Reference No AW300-49-0268

Challenger: 300 – 20003 – 20500

Challenger: 350 – 20501 – 20999

SUBJECT: Potential damage to the Auxiliary Power Unit (APU) Low Oil Pressure Switch Wire

Figure 1

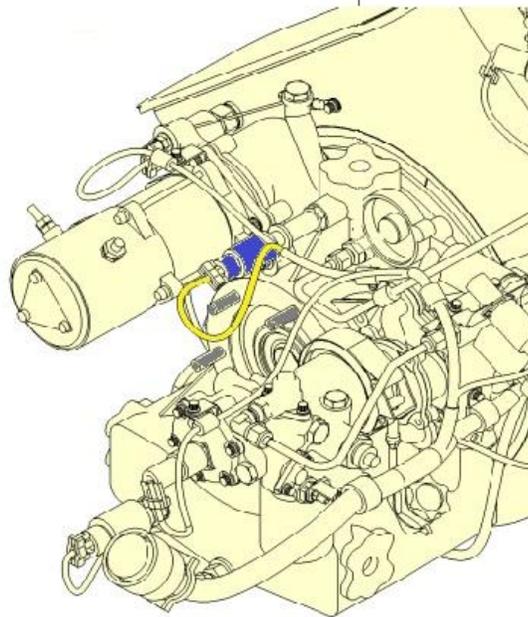
During a recent installation of an APU generator, the LOP switch wire was hanging too low and was caught between the Generator V-Clamp and the QAD coupling. This condition can damage the wire and result in a false low oil pressure CAS messages. Refer to Fig 1.

LOP switch wire pinched at the APU Generator interface flange

When installing APU Generator part number A3579-101/102, make sure that the surrounding wiring is properly secured and out of the way, paying particular attention to the LOP switch part number 3876001-8 wire located just above the generator. It is advised to use a mirror and inspect the top portion of the APU Generator to make sure that no wiring has been caught between the Generator V-Clamp and the QAD coupling.

Associated AMM Task 24-31-09-400-801 will be amended to reflect this caution.
